# Building Inspection Report

FANGS BUILDING INSPECTIONS

**John St , Mernda, VIC, 3754**

### Building Inspection

### Installation NOT fully consistent with drawings

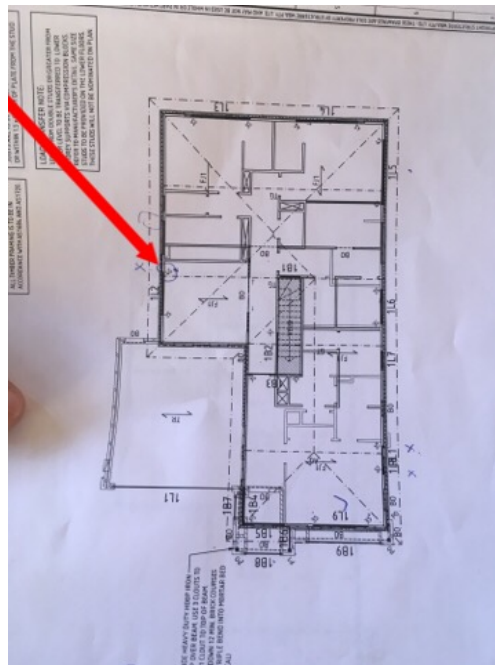
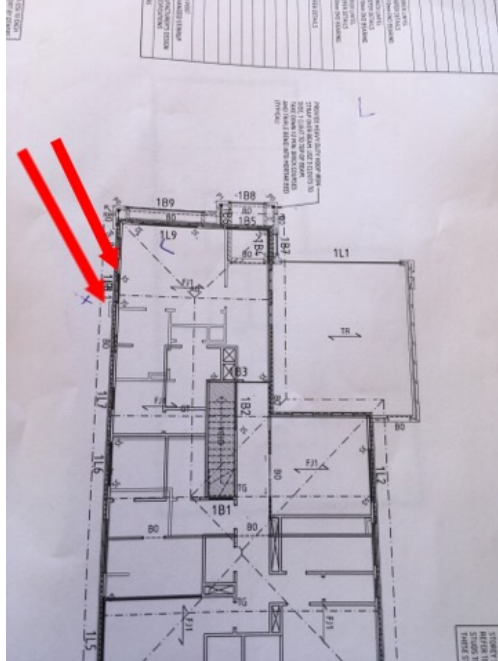
3S showing on the drawings not installed, please check whether drawing is correct or studs should have been installed

One stud missing noted

### Installation NOT fully consistent with drawings

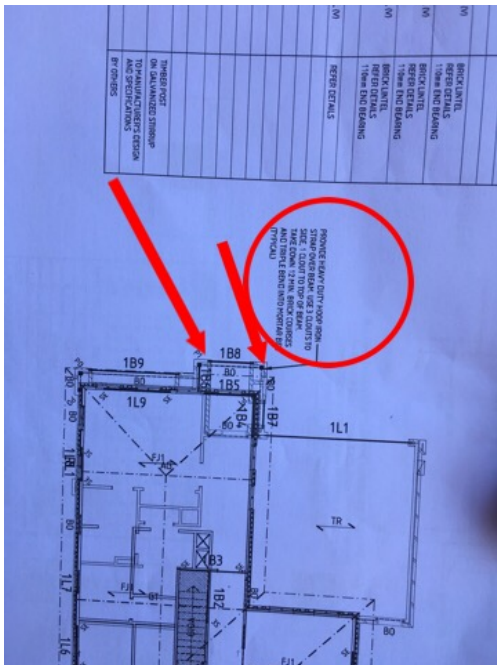
Wrong-sized / grade post(s) installed, please refer to below location(s) and rectify as per AS1684.2 and engineering drawings before plastering

Extend hoop iron, make sure take down 12min brick course

## Timber Cracking and Damage

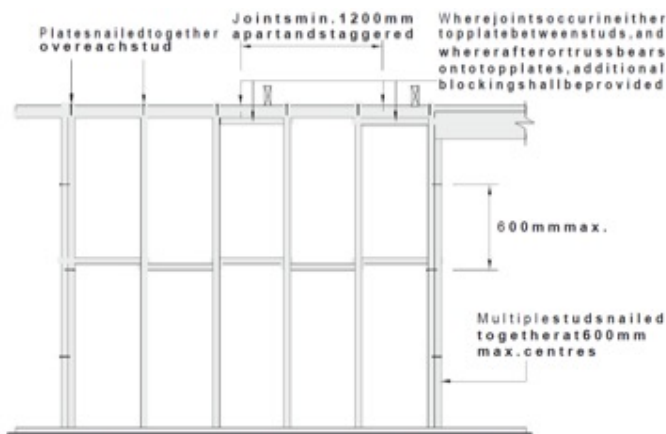
Please refer to below location(s) and replace cracked and damaged timber per AS1684.2 Table 6.1 and engineering drawings before plastering.

### Unsupported Joint

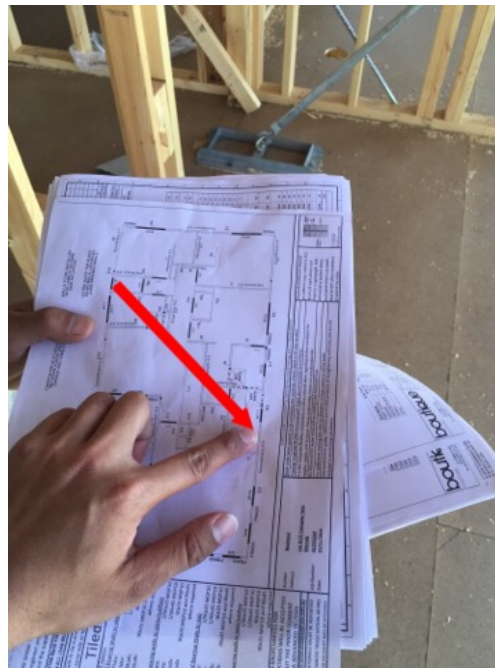
It is a requirement of Australian Standard, A.S 1684 Residential Timber-Framed Construction, clause 2.4 Stud/Plate Lamination, that 'where joints occur in either top plate between studs, and where rafters or trusses bears onto top plates, additional blocking shall be provided.'

Please refer to below location(s) and rectify the issue as per AS1684.2 Figure 2.9 and engineering drawings before plastering

### Out of Plumbing Exceeded 5 mm over a 1.8 m height

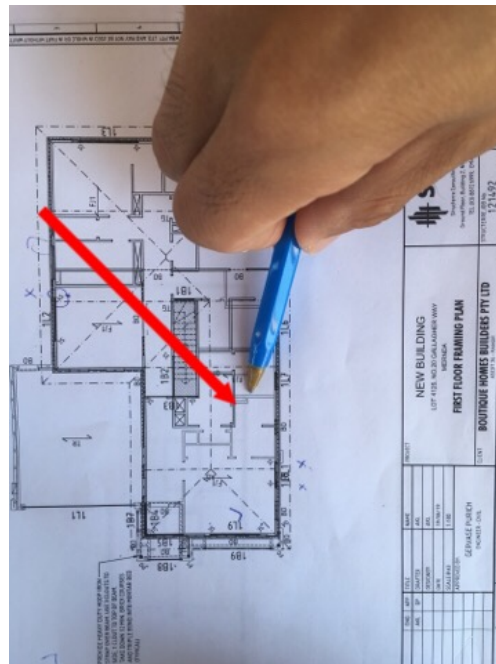
Posts and wall frames are defective if they deviate from vertical by more than 5 mm over a 1.8 m height.

Please refer to below location(s) and rectify the issue(s) as per Standards and Tolerance 2015 and engineering drawings before plastering.

## Shear Block to Non-Load Bearing Braced Wall Not Installed

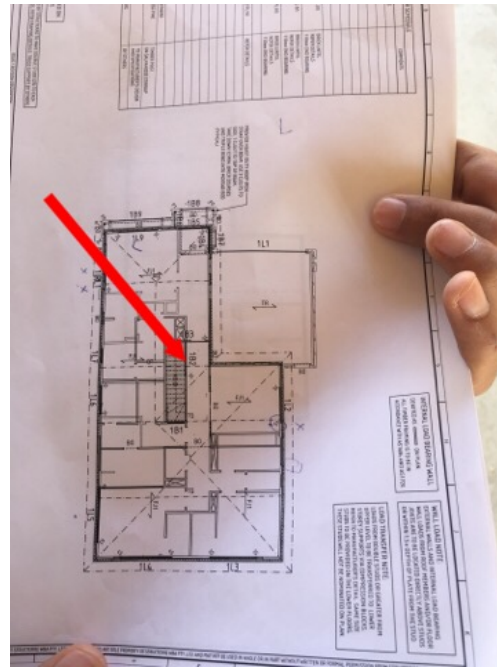
Install Shear Block to Non-Load Bearing Braced Wall

Please refer to below location(s) and rectify the issue(s) as per AS4440 2.2.3 and AS1684.2 6.2.5.2 and engineering drawings before plastering.

## Nail(s) missing on lintel to jamb studs (2/75x3.05mm nails each joint)

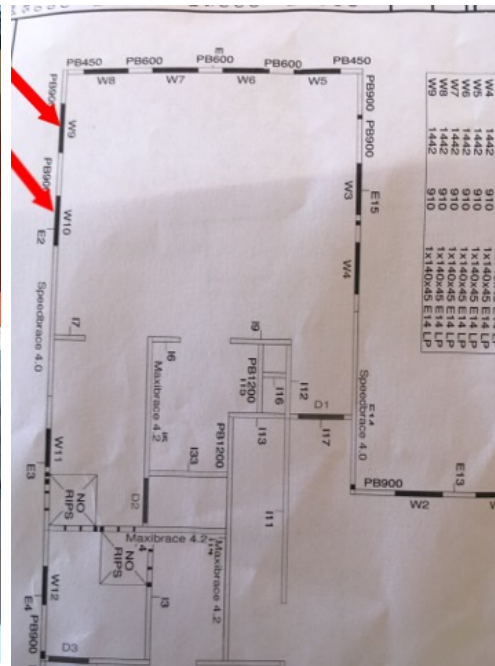
Nail(s) missing or not affixed properly, please refer to below location(s) and rectify as per AS1684.2 and engineering drawings before plastering

2/75 x 3.05 mm dia. nails at each joint
